dz-0-2-comment-seaman-uml: Suggested replacement for Figure 10-2 and 10-3

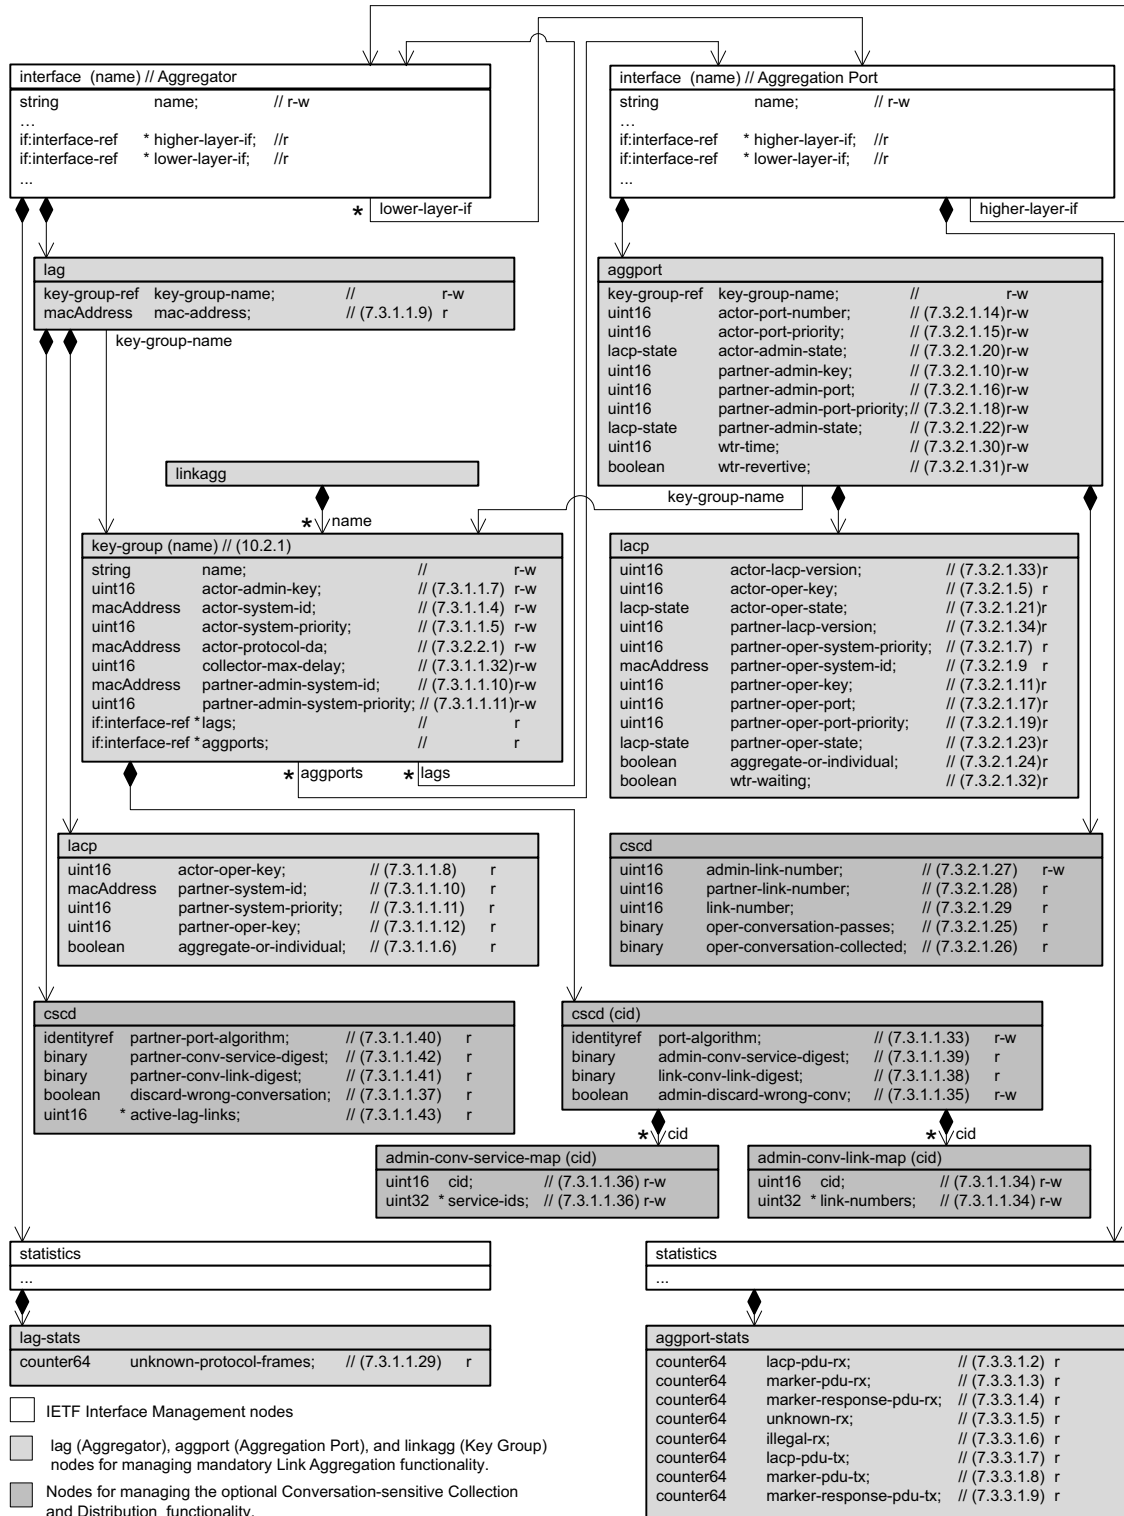
The following Figure for reference when considering comment only, not suggested ‘as is’ addition to the draft standard.
